814-003-14

ADDENDUM NO. 1

PROPOSAL FOR CONTRACT FOR
Lincoln Christian School
HVAC Upgrades
Lincoln, Nebraska

Athletic ("LC") Logo

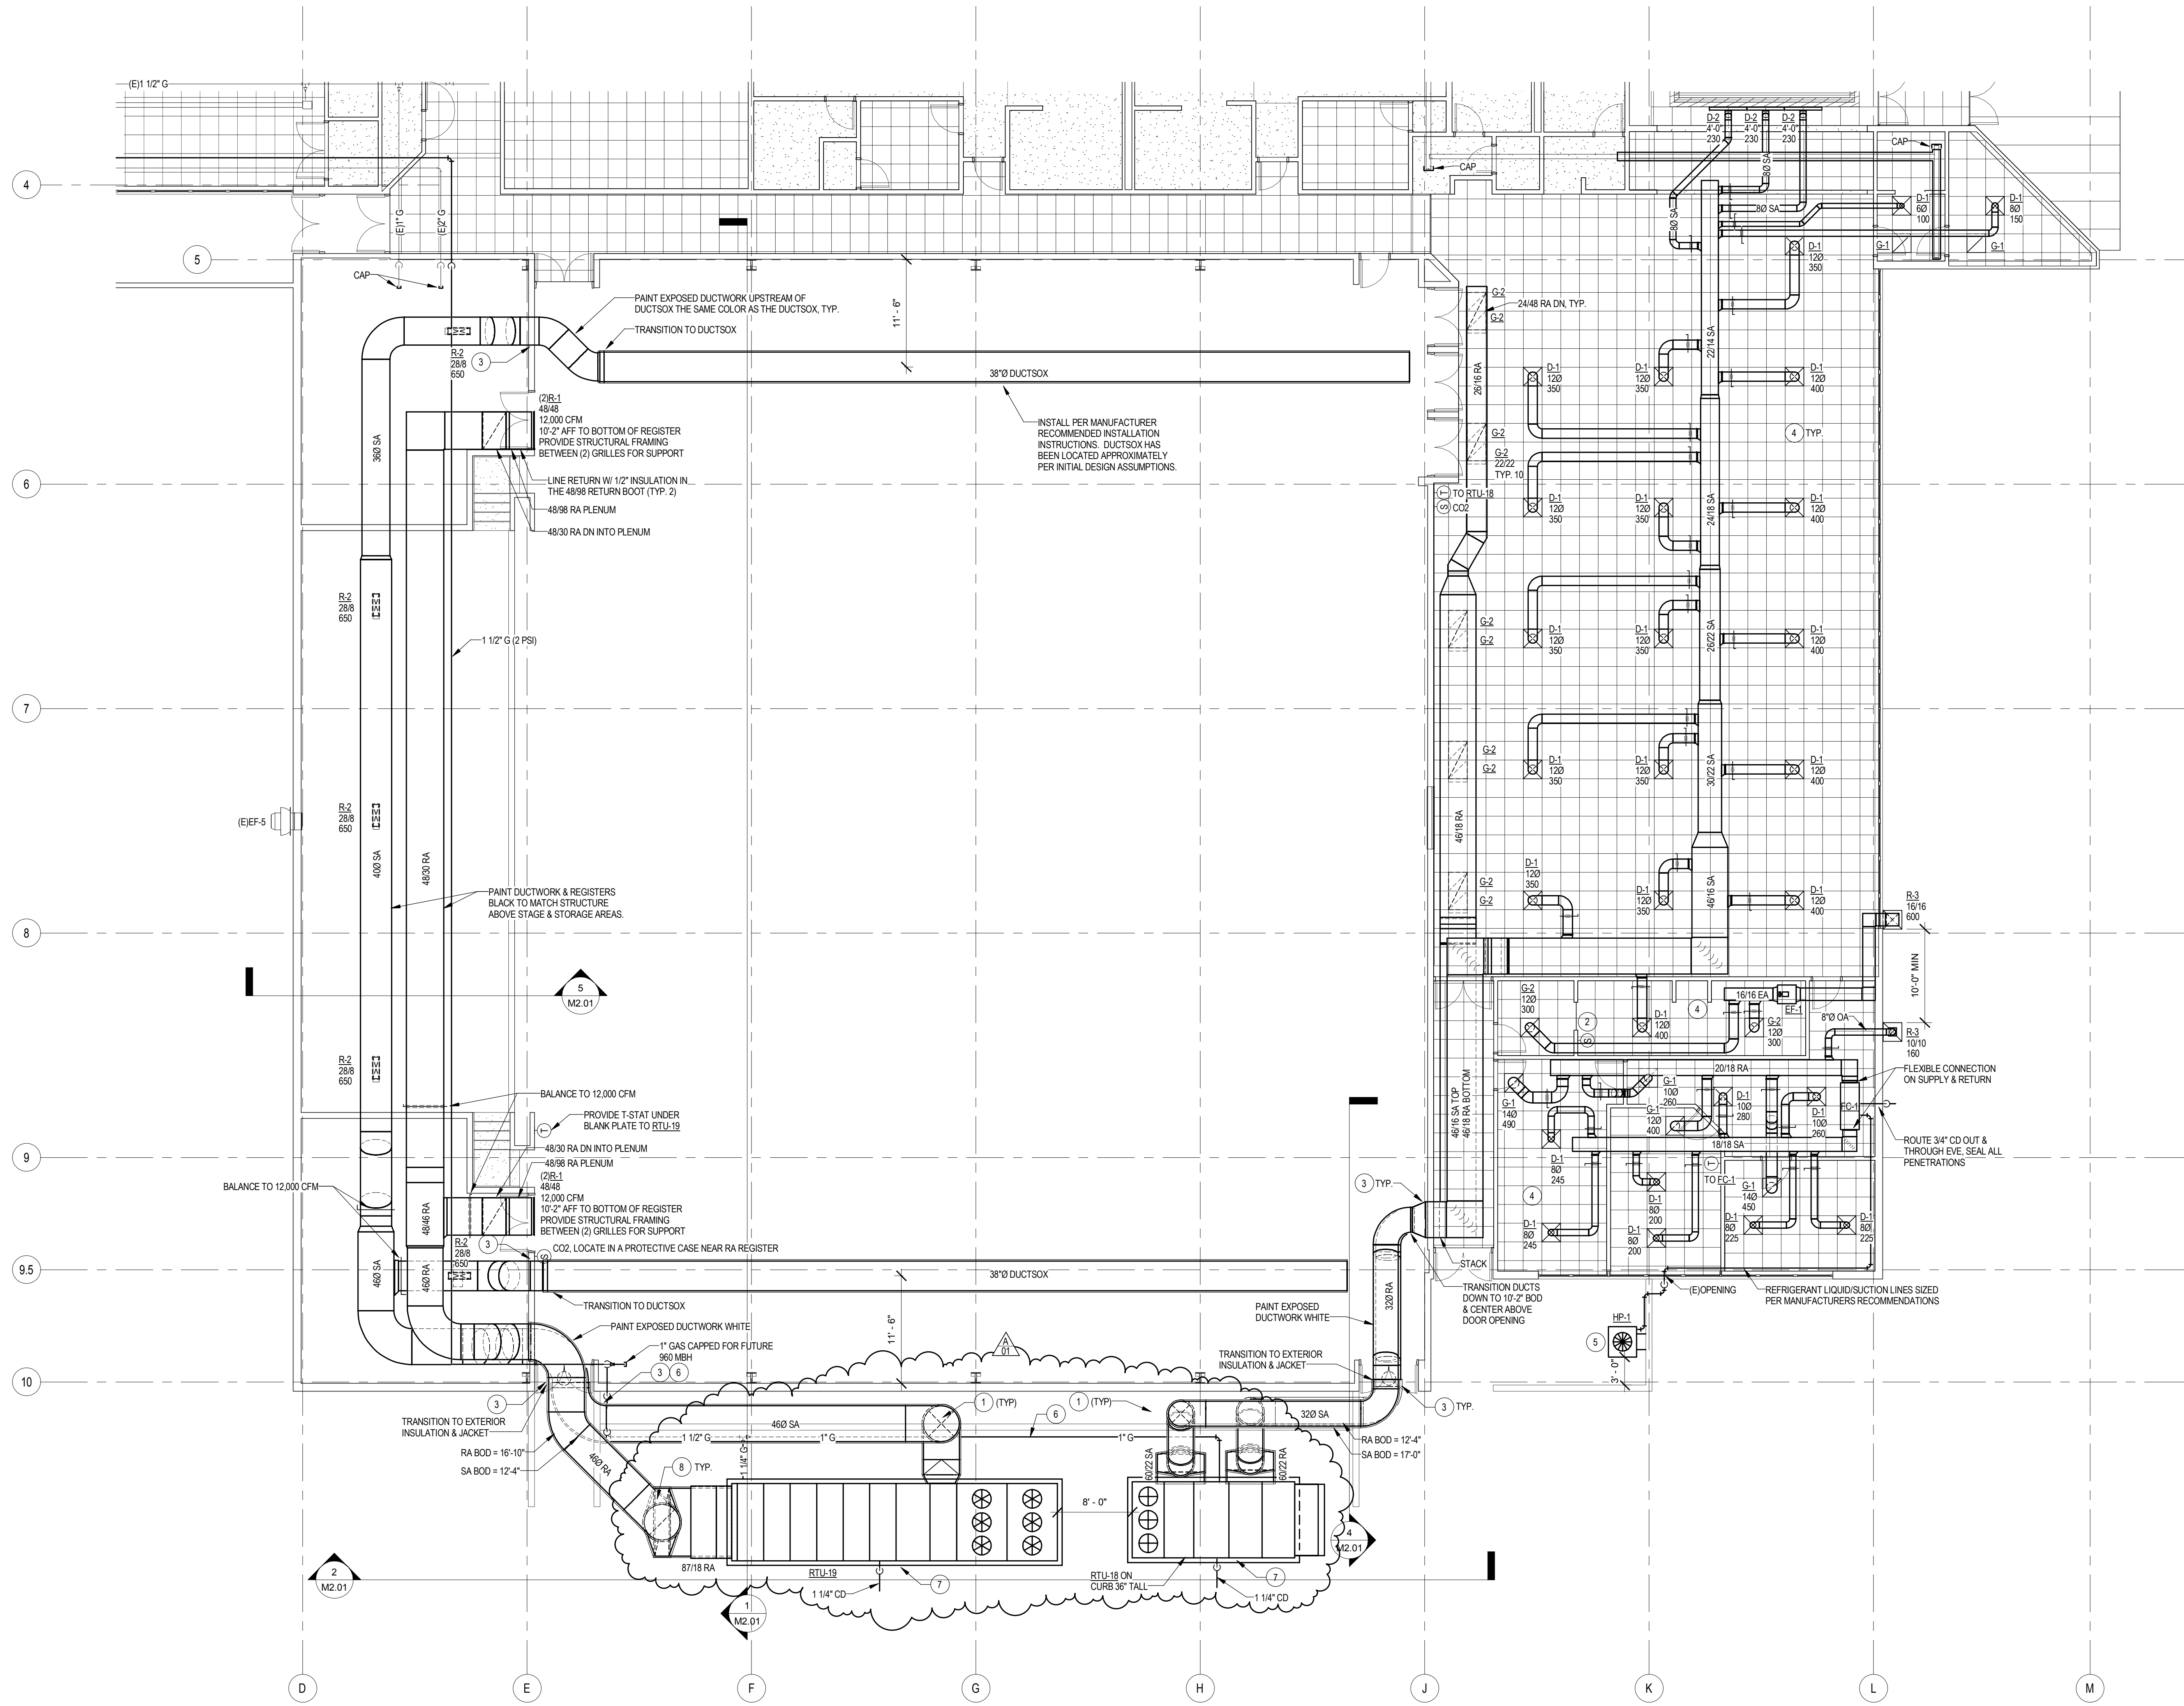
Per add alternate A-5 provide a cost to add the Lincoln Christian “LC” Athletic Logo (see attached pdf for letter type, style, and color). A total of two logos at each end facing the gym, this will be provided on both Ductsox runs.

First Floor HVAC Plan - Gym

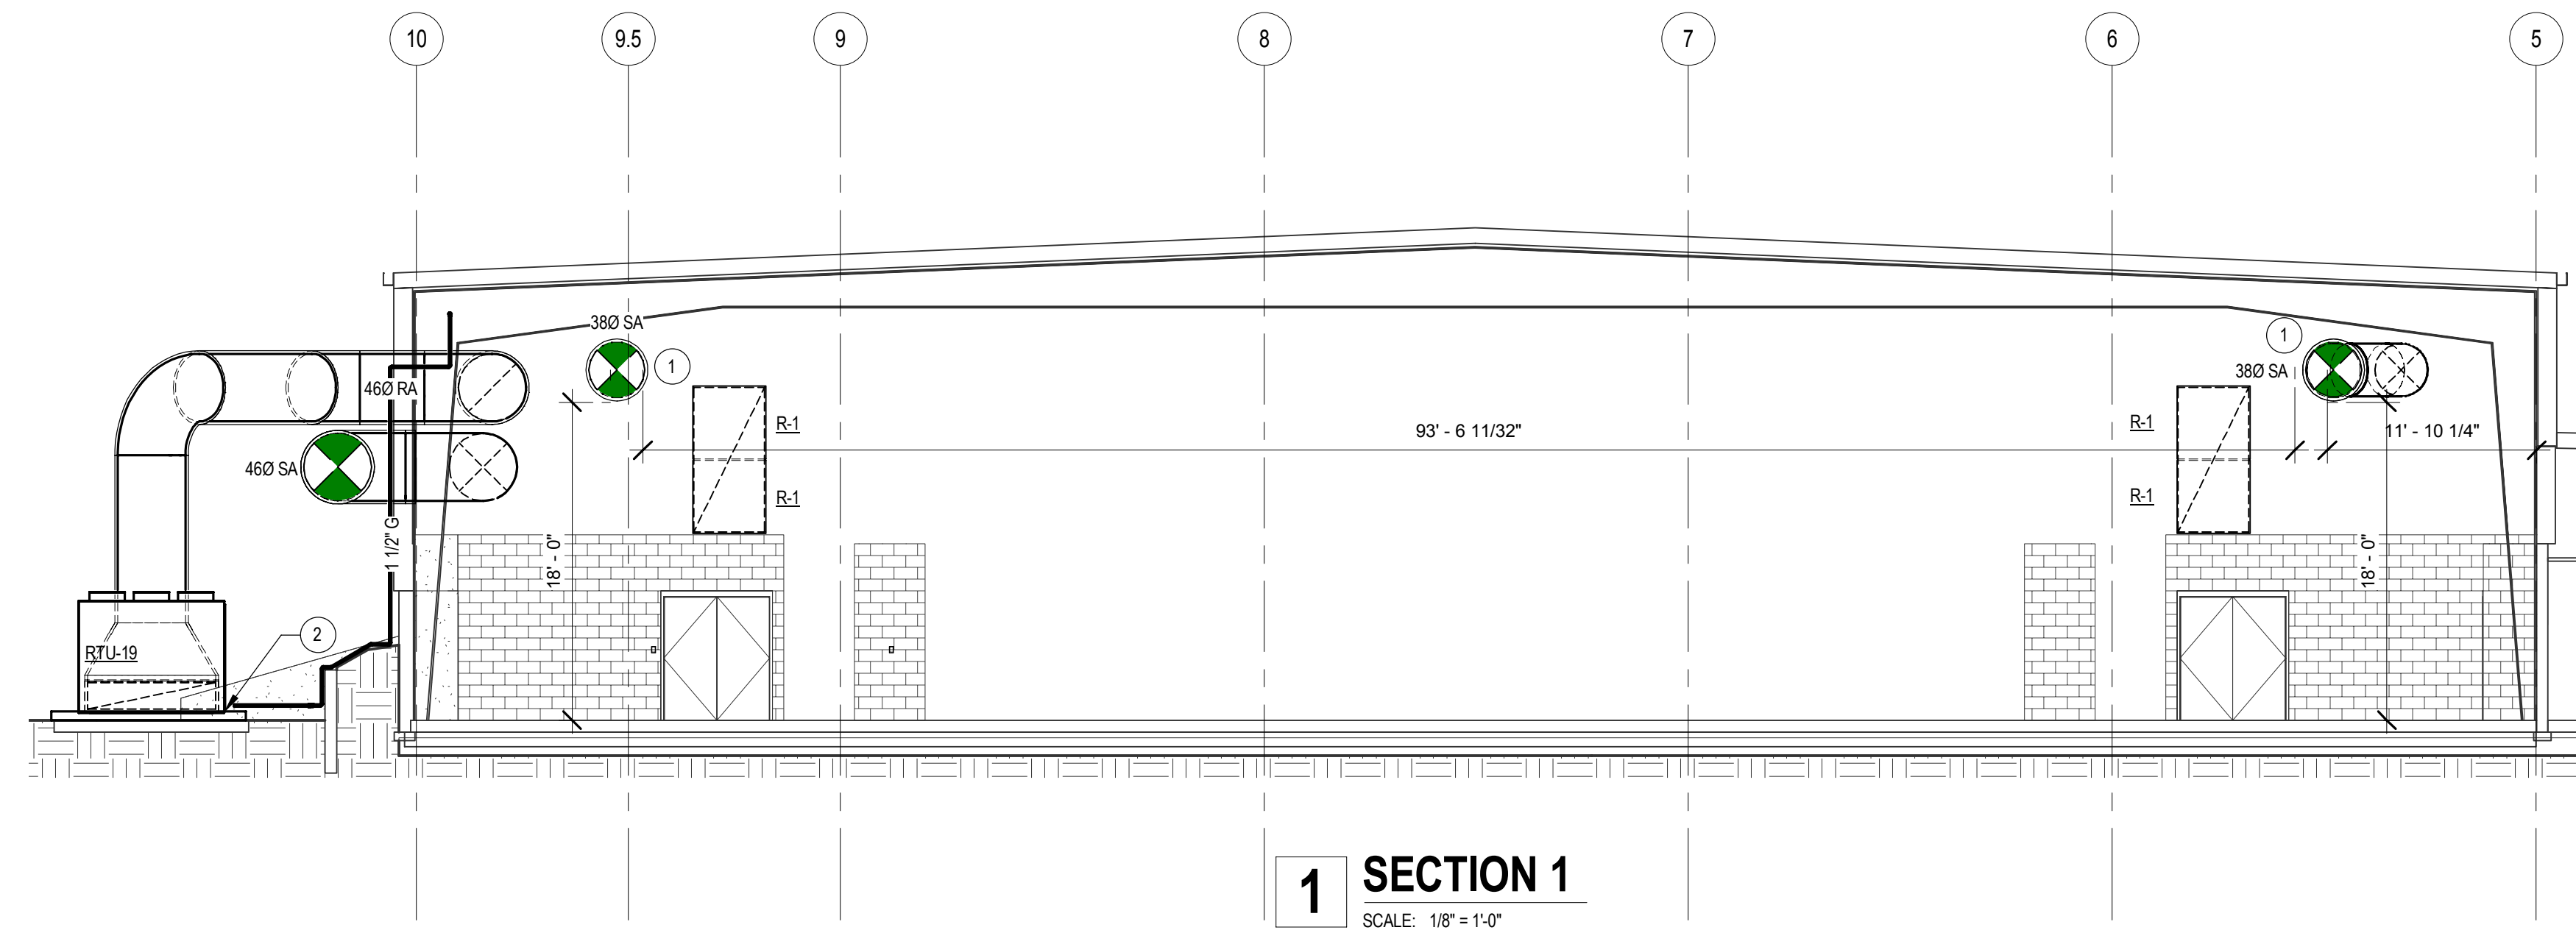
M1.02 has been re-issued in its entirety, per finalized selections for RTU-18 & 19, see changes, to include but are not limited to ductwork, location, gas piping, condensate piping, and all associated accessories.
